CITY PLAN COMMISSION STAFF REPORT

CD-CPC-2025-00124, 00140

Martin City FlexCaves

September 17, 2025

B3/B4 Uses
 3.19 Acres

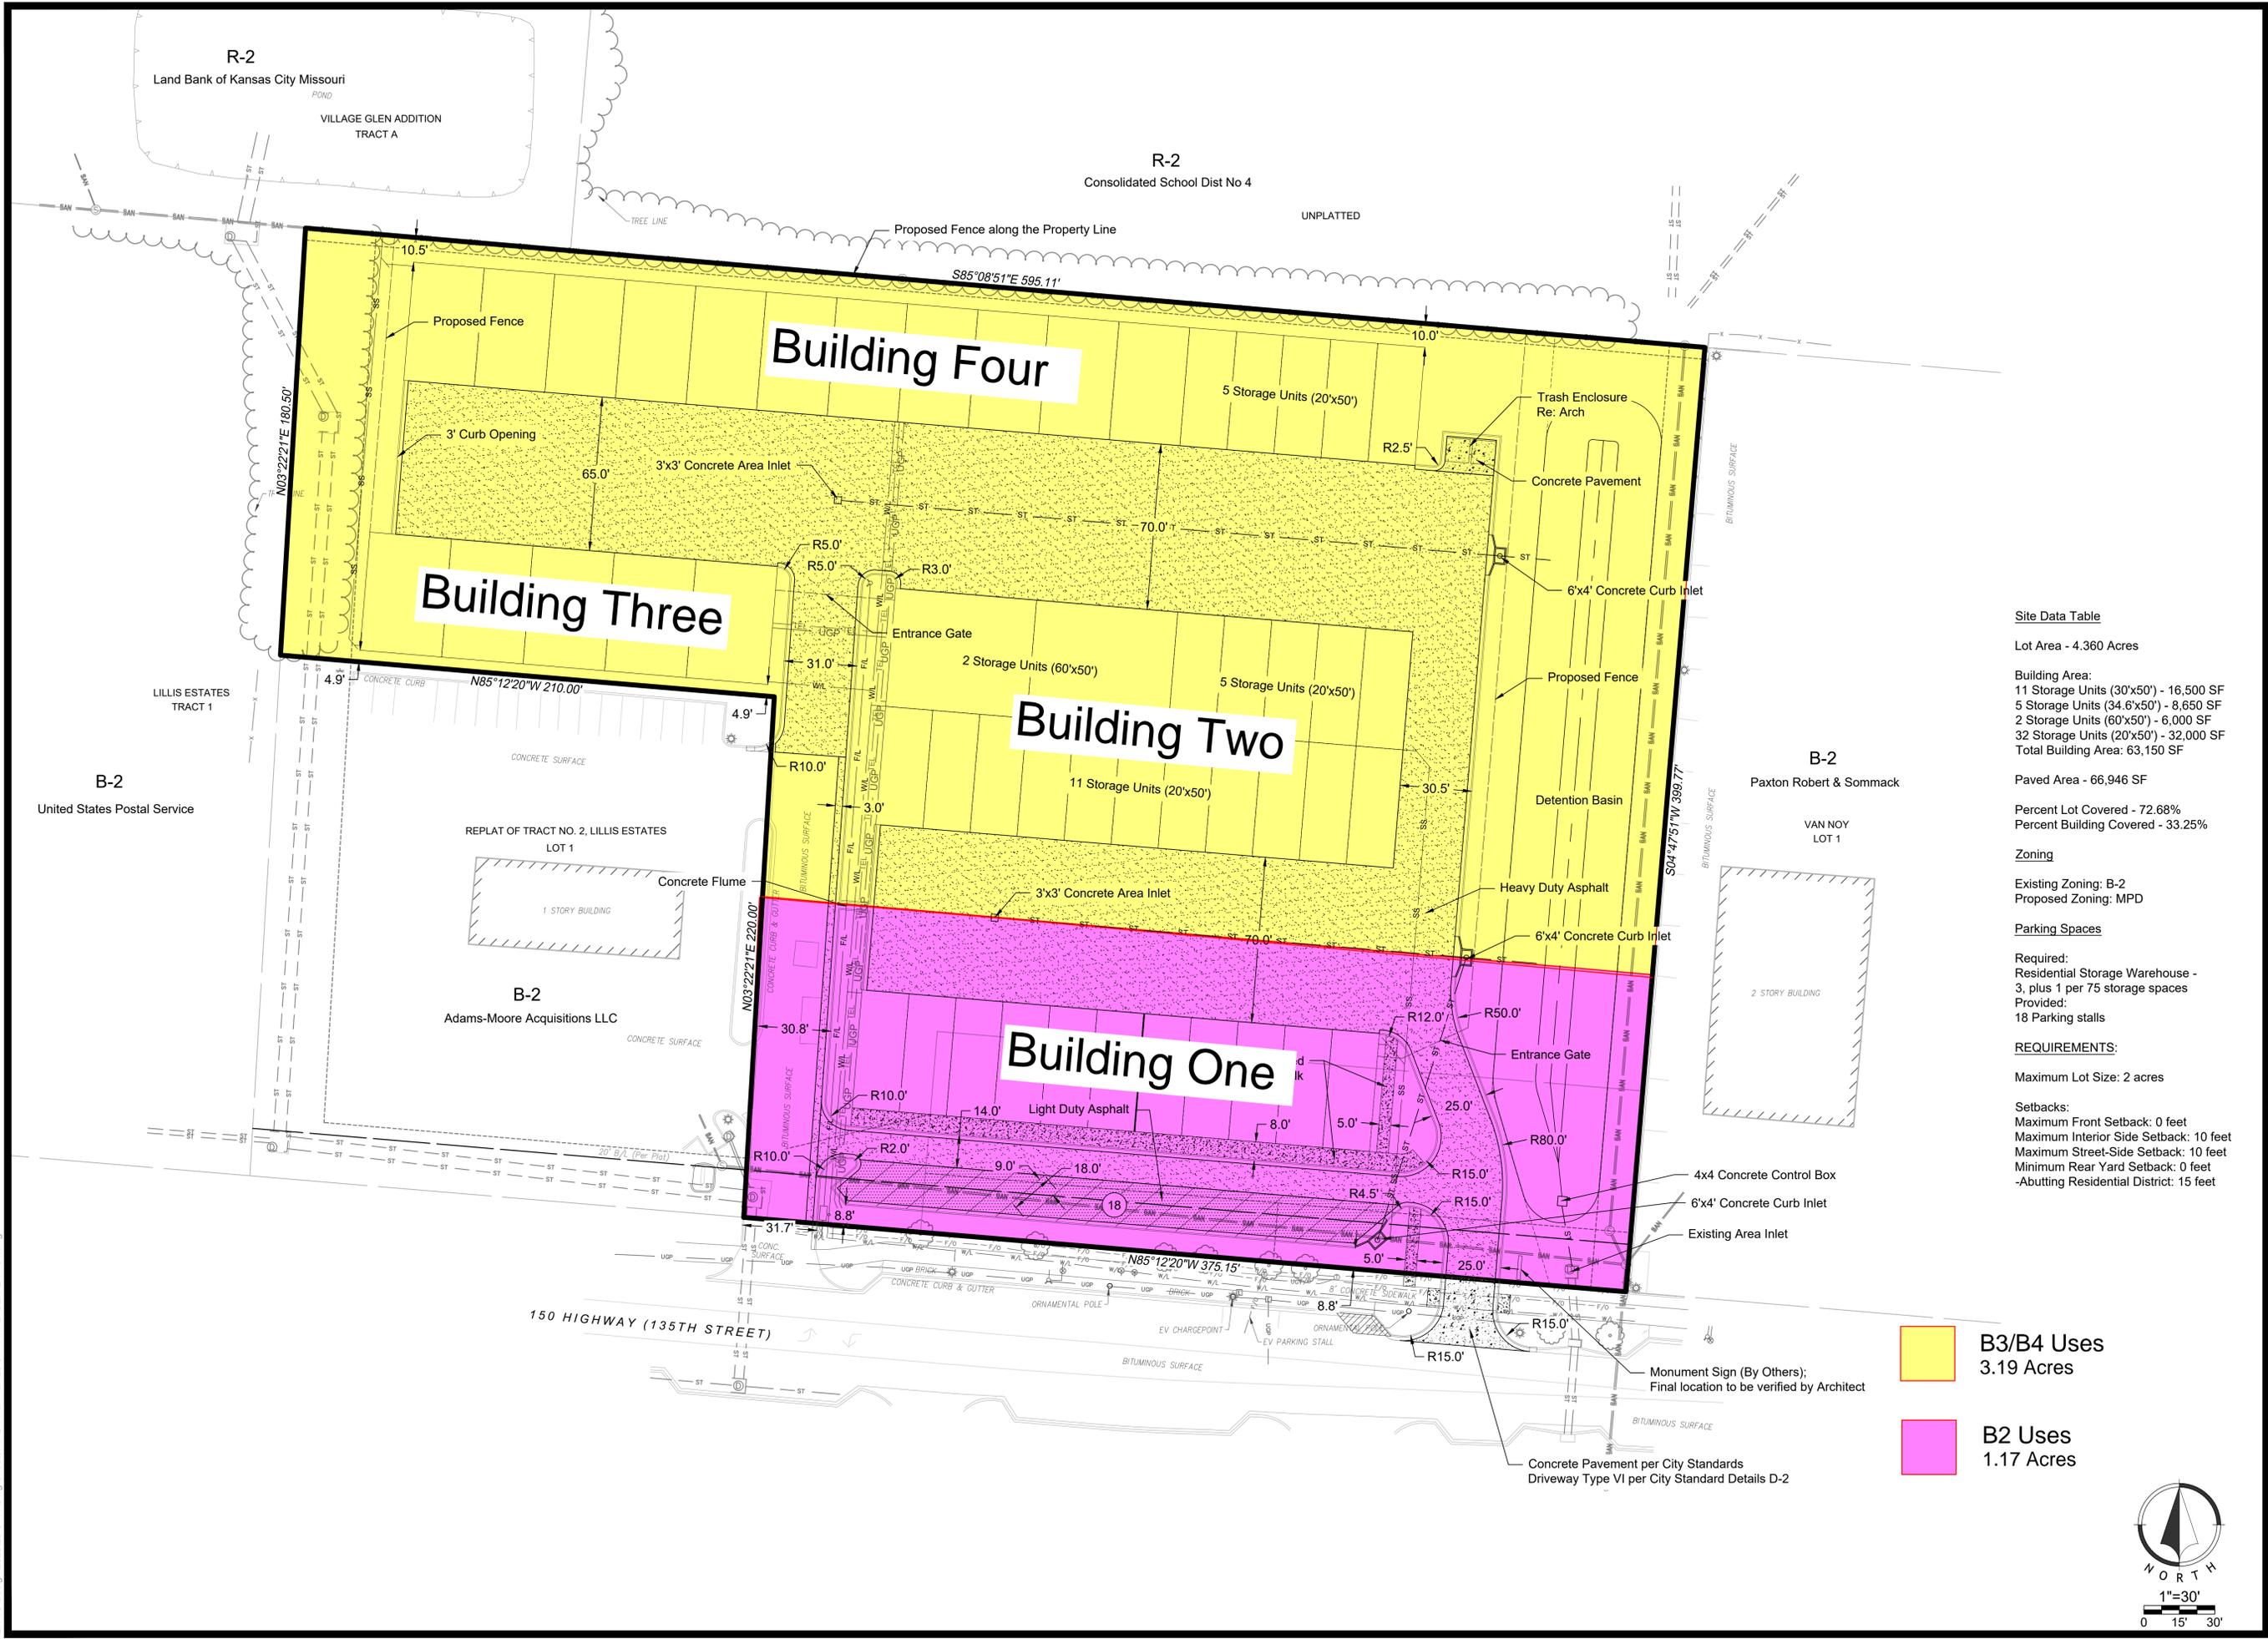
This proposal is not consistent with the future land use plan which necessitates the accompanying Area Plan Amendment. The applicant has submitted an Area Plan Amendment application to update the northern portion of the site from Mixed Use Community to Commercial.

As stated in previous sections, the proposed plan has low alignment with goals in adopted plans like the Area Plan and KC Spirit Playbook. The Community Planning Division requested an Area Plan Amendment to the northern portion of the property to better align the commercial uses with the area plan.

However, allowing additional uses that are included in the B4 heavier commercial zoning would potentially have negative impacts on adjacent properties and would also not contribute to a downtown pedestrian environment. Additional uses allowed in a B4 zoning district requested by the Applicant include: self-storage, manufacturing and production, warehousing, wholesaling, storage and freight movement. Typical manufacturing and production uses allowed in the B4 include; asphalt plants, concrete plants, textile mills; textile product mills; apparel manufacturing; leather and allied product manufacturing; wood product manufacturing; paper manufacturing; chemical manufacturing; plastics and rubber products manufacturing. Truck, smoke, noise and pollutant impacts of heavier manufacturing uses would be detrimental to the surrounding properties and the pedestrian customer facing type of activity recommended for downtown Martin City. Self-storage does not encourage pedestrian activity.

If the area plan amendment for a portion of the subject property is approved along with MPD zoning, the MPD needs to be carefully created to match the Martin City Area Plan goals as much as possible and not include uses which could be nuisances or dangerous to pedestrians or the adjacent school and residential neighborhood.

Landscape Plan

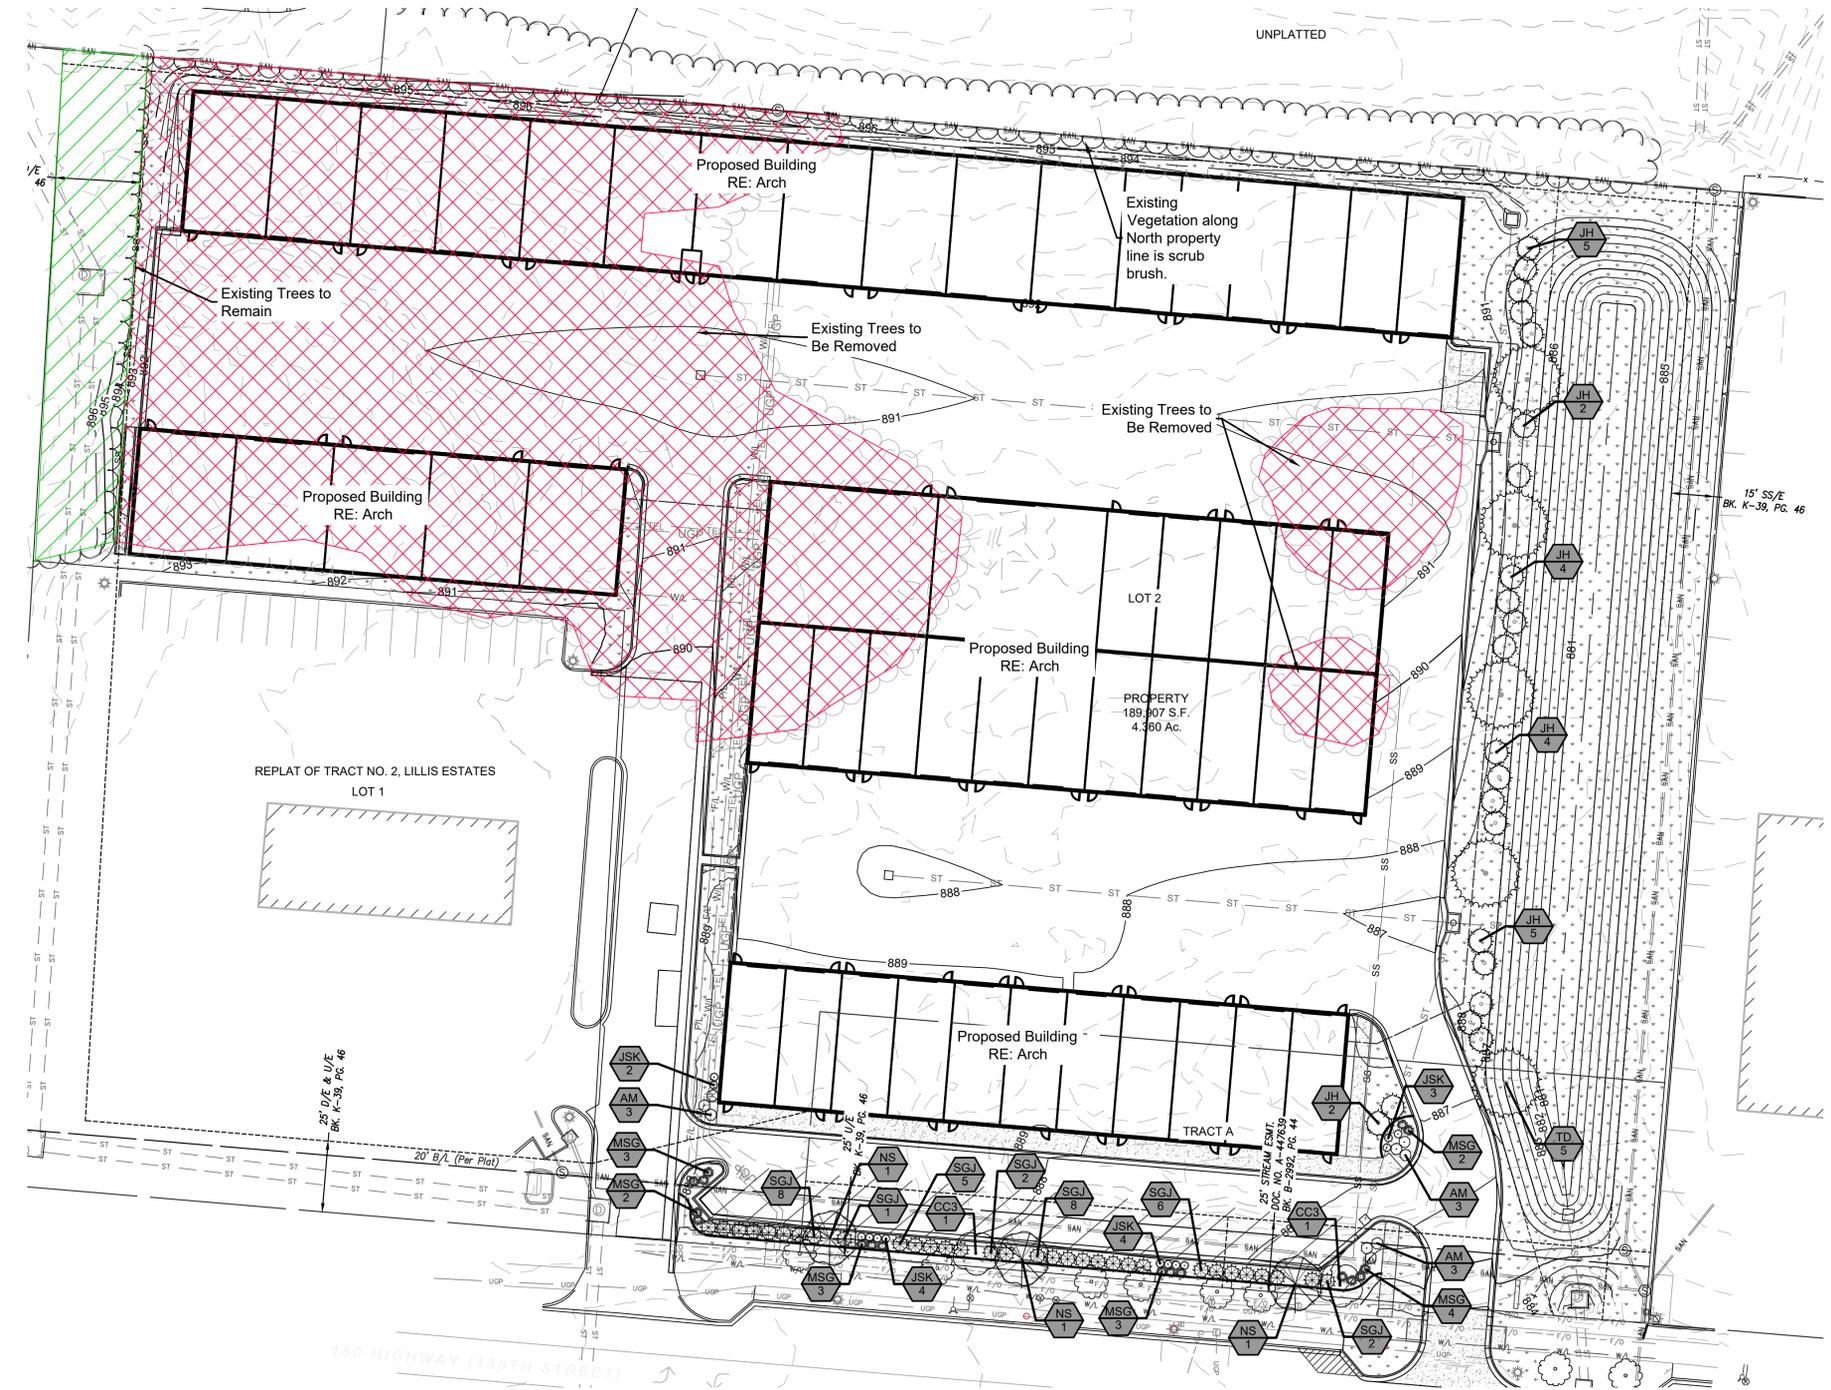
Staff requested that the applicant move the “ShopCaves” to the street and move the parking to the side to more closely align with the Area Plan and context of the corridor to the north. The applicant did not update plans; however they did provide additional screening of the parking area in the form of landscaping.

screen the parking from East 135th Street. A masonry wall was requested by staff to provide additional screening but was not provided by the applicant.
